**Planning Department
168 North Edwards Street
Post Office Drawer L
Independence, California 93526**

November 30, 1998

**COMMENTS ON THE PREAPPROVAL DRAFT ENVIRONMENTAL ASSESSMENT (EA):
INTERMODAL TRANSPORTATION OF LOW LEVEL RADIOACTIVE WASTE TO THE
NEVADA TEST SITE.**

MOJAVE NATIONAL PRESERVE

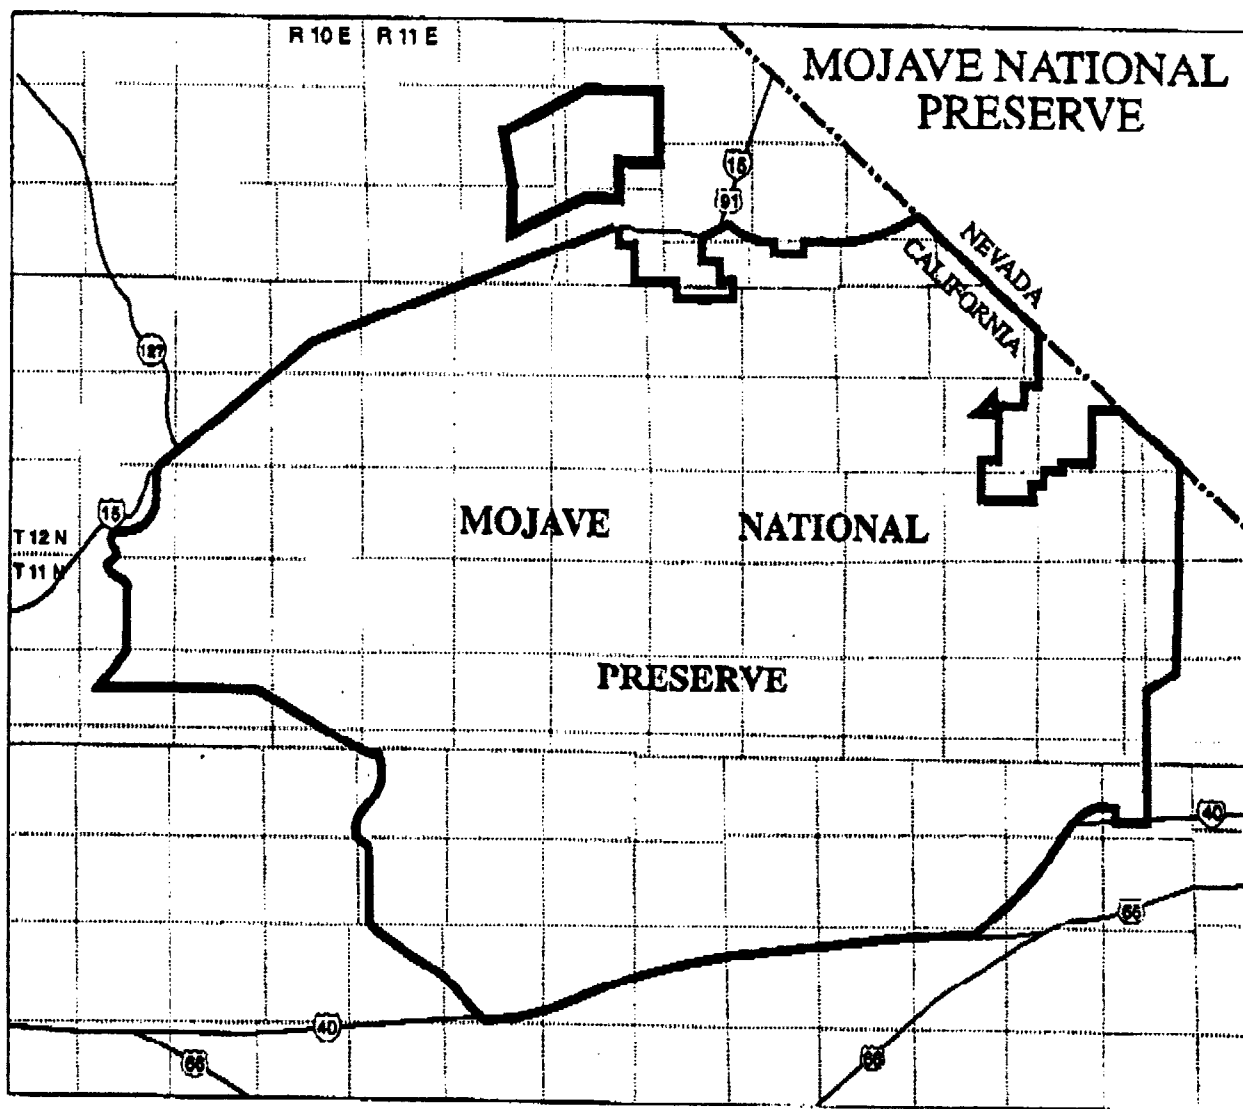
4. Page 2-13, Lines 20 and 21, Please indicate which portions of the route cross or are adjacent to the Mojave National Preserve.
5. Page 2-13, Lines 24 through 26 state, "The results of the study eliminated three more potential transfer sites: (1) the UP Apex siding northeast of the Las Vegas Valley, (2) the Valley Intermodal facility near North Las Vegas, and (3) the UP Dunn siding in southeastern California." The *NTS Intermodal Transportation Facility Site and Routing Evaluation Study* (DOE, 1998) did not conclude that these sites should be eliminated⁴. At a minimum, the Valley Intermodal facility, which was the original proposed action, should be evaluated.

33. Page 4-3, Section 4.2.1.2 Land Use, This section does not include any discussion of the Mojave National Preserve, Hollow Hills Wilderness or the Saddle Peak Wilderness all of which are adjacent to the proposed route either along Highway 15 or Highway 127 (maps enclosed). Please include a discussion of how this transportation route would affect these areas.

HOLLOW HILLS WILDERNESS AREA MAP 42

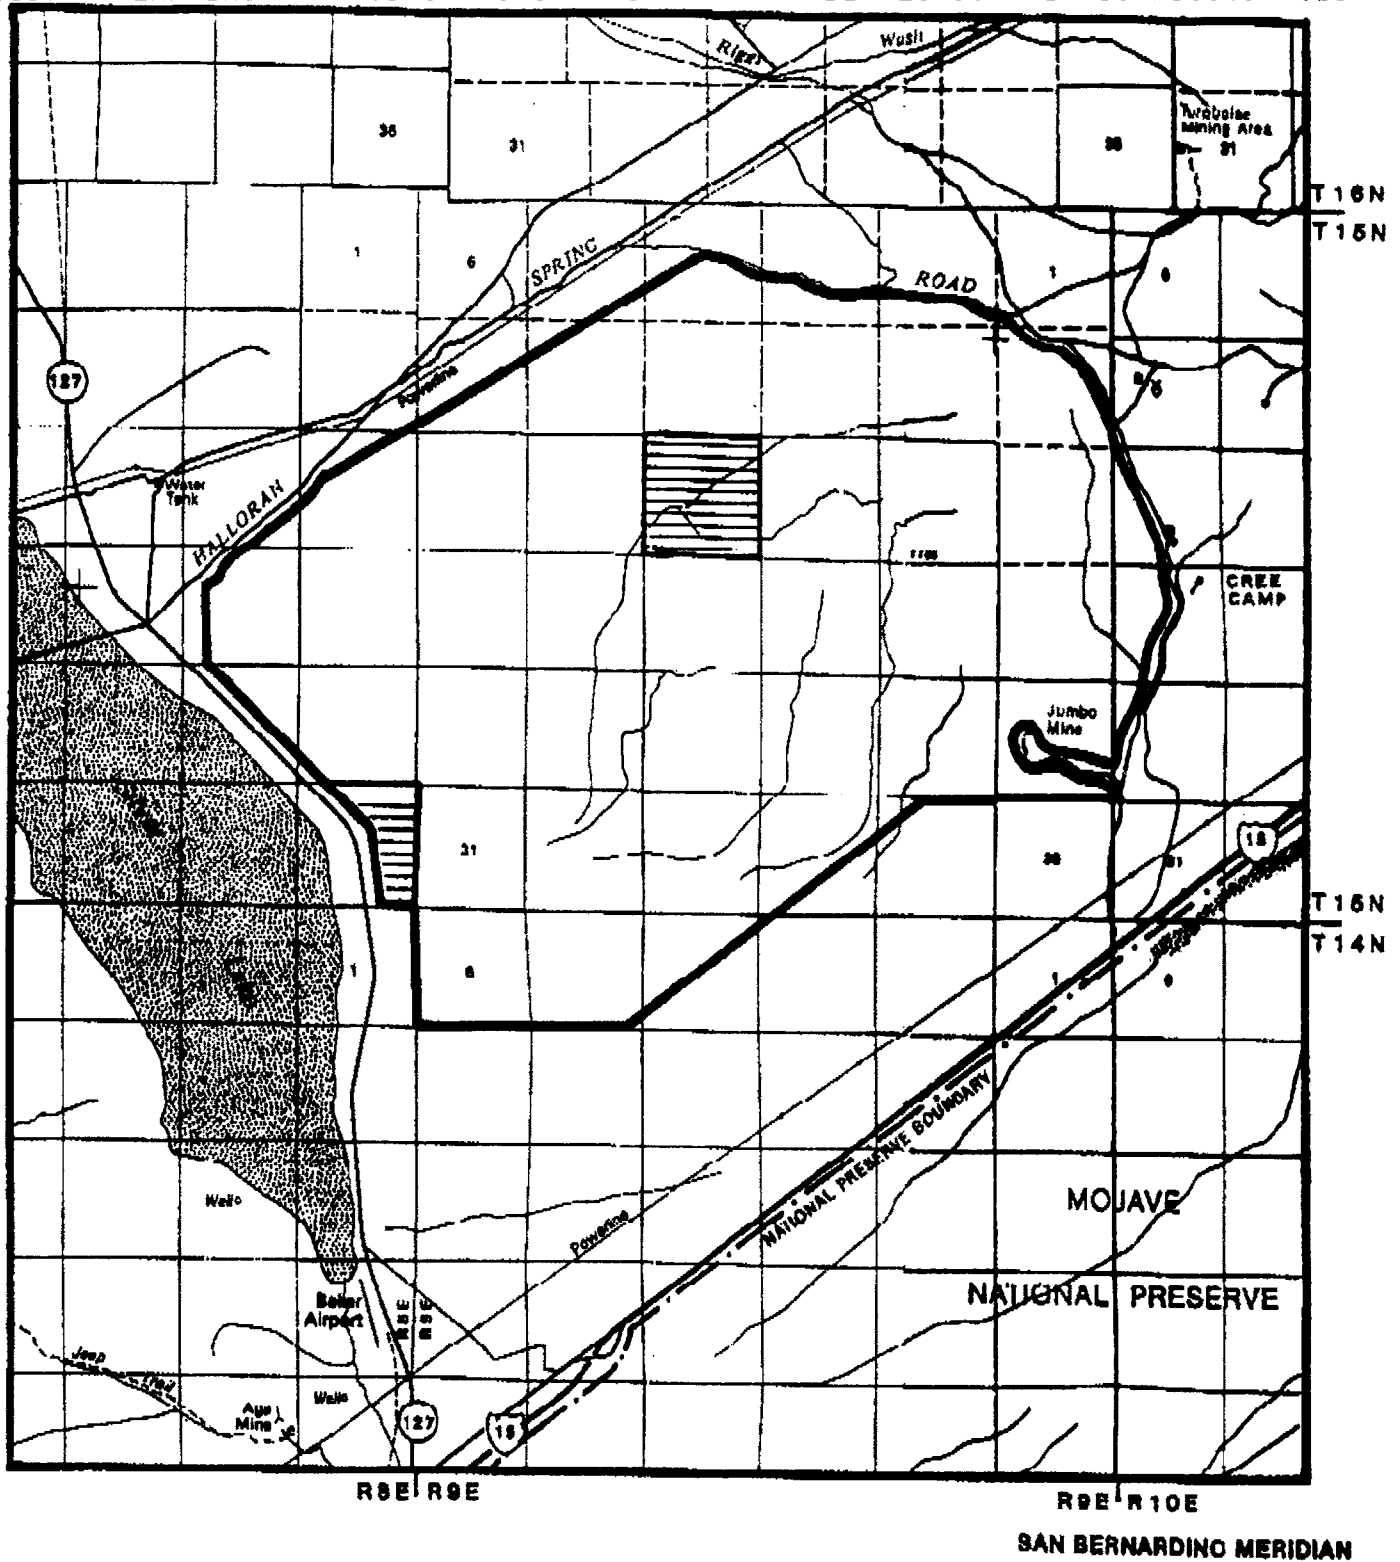
41. Page 4-6, Section 4.2.1.9 and Page 4-11 4.2.2.9, Biological Resources, The proposed route is adjacent to the Hollow Hills Wilderness. As stated in the "Bureau of Land Management Wilderness Areas" June 1995 document the Hollow Hills Wilderness may contain both Desert tortoise and the Mojave fringe-toed lizard. This issue needs to be addressed in this alternative. What are the potential impacts to these species?
